Loudoun County, Virginia

ADDENDUM NO. 6

RFQ 58772

The following changes and/or additions shall be made to the original Invitation for Bid RFQ 58772: Construction of the New Loudoun County Courthouse. Please acknowledge receipt of this addendum by signing and returning with your bid.

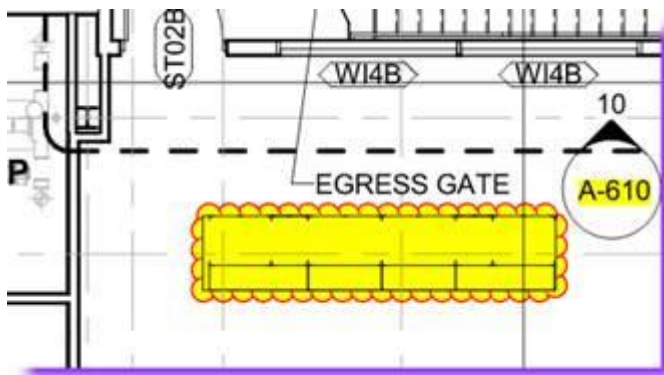
Q4: Confirm countertop and cabinet materials at Judges restrooms.

A4: Quartz Agglomerate Countertops, refer to section 123661.19. Basis-of-design for the vanity is Kohler Damask Vanity K-99513.

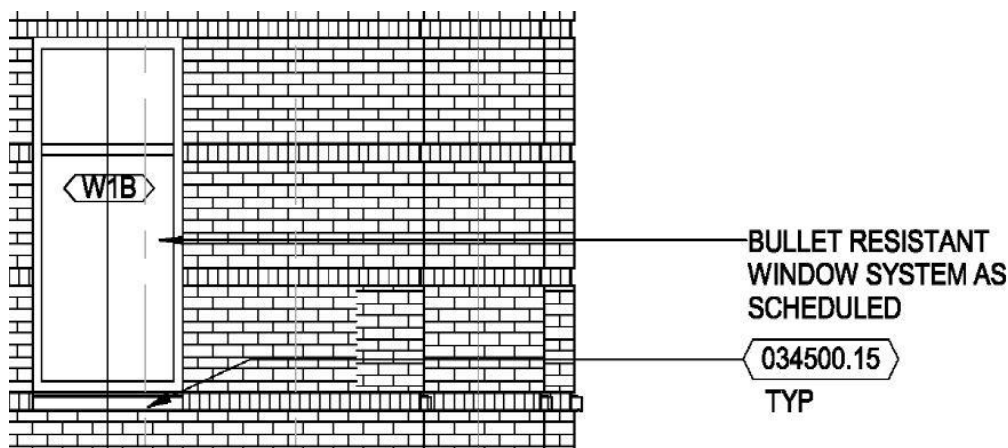
Q30: We were just notified by one of the manufacturers for the security gate for this project with a couple of issues. Can you please clarify the following items.

- The specifications call for 6 gauge welded wire infill but the drawing on AS-126 call for solid panels.
- The security gate is for one gate with two independently operating bi-fold panels.

A30: 1. Provide gate with solid panel infills.

2. There are two bi-fold panels that operate simultaneously.

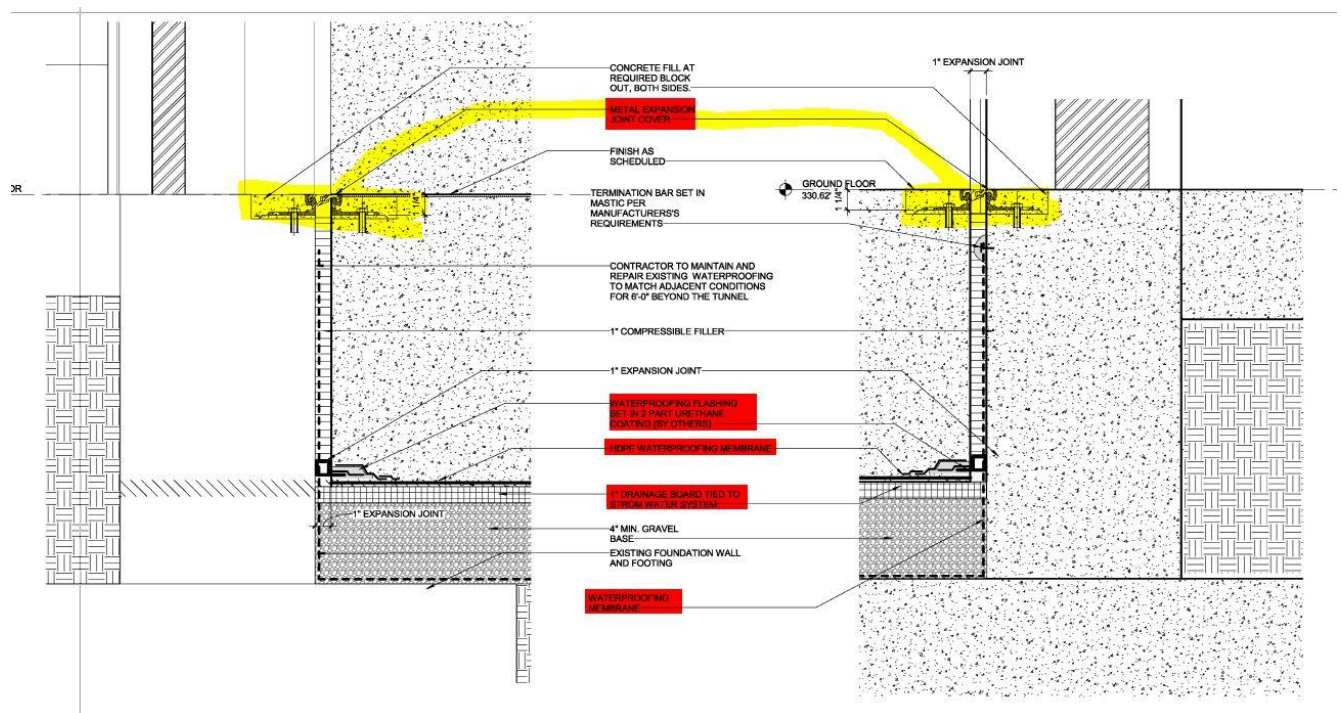
Q32: The response from Q5/A5 on Addendum #3, also conflicts with the response for Q4/A4. This response states “The extent of bullet resistant openings is clearly indicated on the exterior elevations (A-200 series) and on A-613. Please note that some windows require bullet resistant glazing in the upper glazing and not the lower (e.g. CW7B). Please advise.

A32: The response from Addendum #3 in regards to the curtainwall glazing is correct, all windows labeled GL-3 are to be bullet resistant and the entire framing system that contains glazing designated as GL-3 shall be bullet resistant regardless if the system also includes non-bullet resistant glazing as well (example “CW7”). Glazed Aluminum Curtain Walls and Security Windows where GL-3 is indicated to be installed must comply with Ballistics Resistance rating of Glazing GL-3 as indicated in Specification Section 088853 and Section 085820. Refer to revised drawing A-613 and revised specification 084413 included with this addendum.
